Ref: 204327A/Do2

Oakdale South Estate – Review of the SLR September 2015 Noise Impact Assessment

- *DA Noise Impact Assessment, Oakdale South Estate, Milner Avenue, Eastern Creek, Report Number 630.11166, Revision 2, 8 September 2015*

Figure 1 SLR noise logging locations (extract from SLR Report)

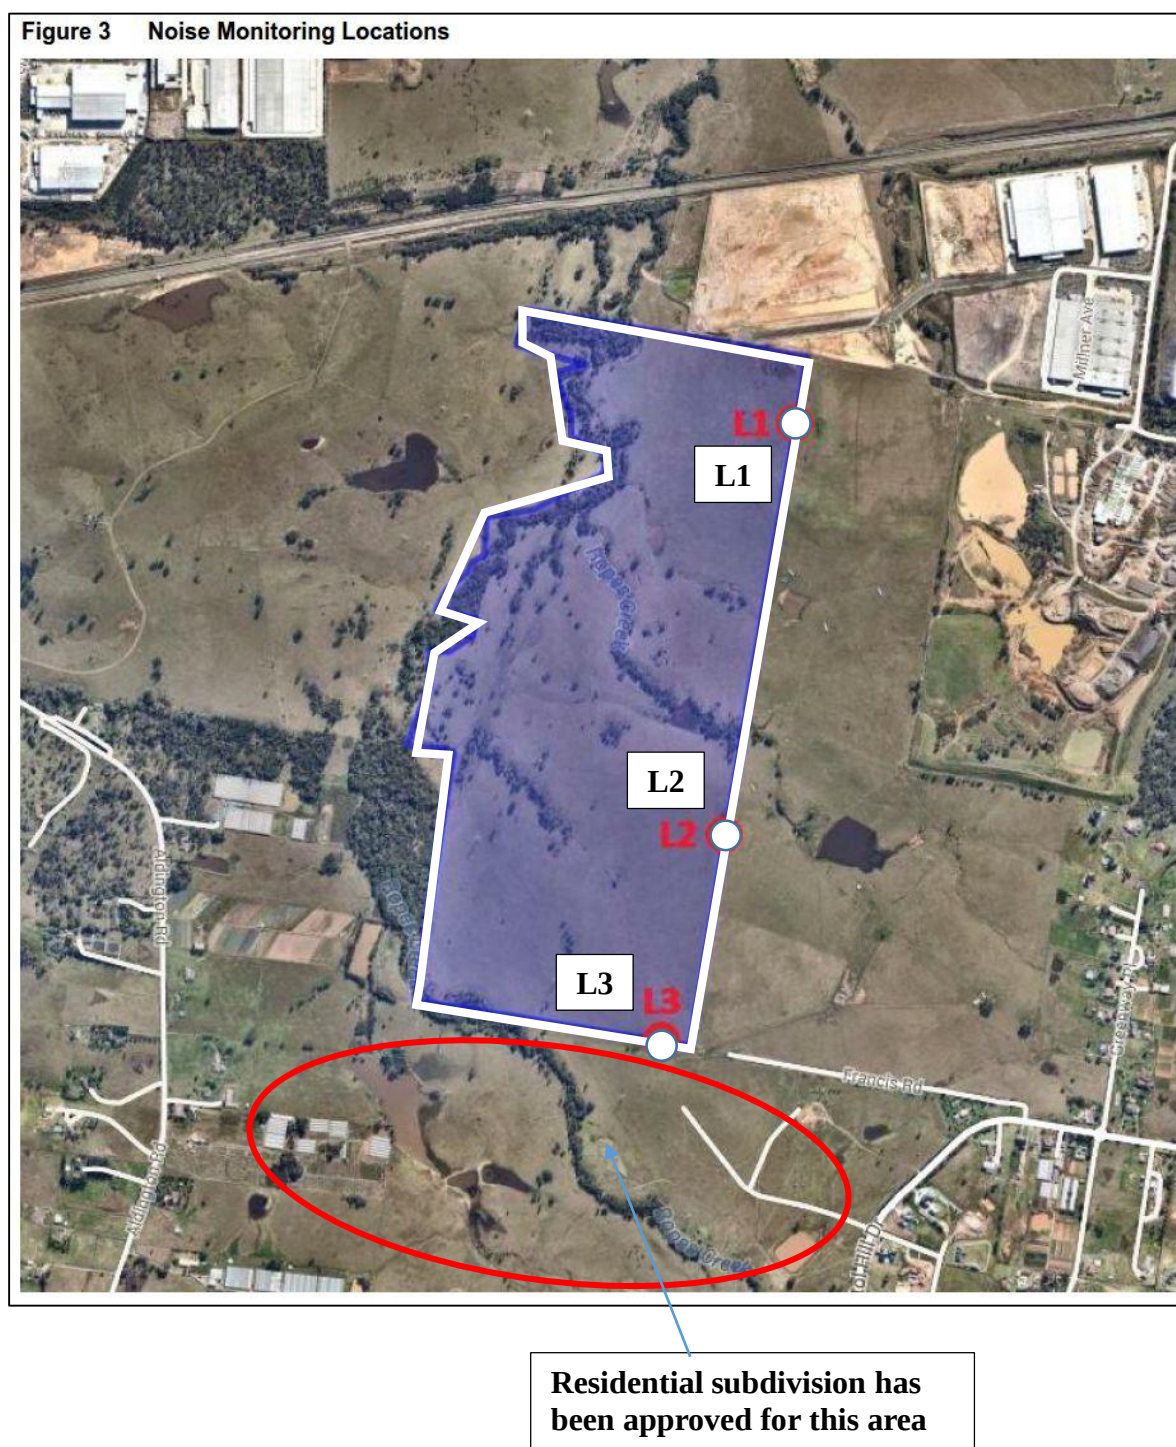
The background noise monitoring carried out by Wilkinson Murray found frequent periods during night-time when background sound levels were below 30dBA. The SLR Report assumes that the background sound levels are:

- 32dBA for assessment of operational noise;
- 44dBA for assessment of sleep disturbance criteria.

At the very least, the noise loggers used for the SLR assessment should have had filters to exclude insect noise. In addition, night-time sound level measurements should have been carried out once it was clear that the background sound levels were anomalous.

Figure 1 and Figure 2 show the two relevant sites for the two impact noise assessments and the noise logging locations used by SLR and WMPL, respectively.

The WMPL Report labelled this area as “Future Residential” but Residential subdivision has been approved for this area
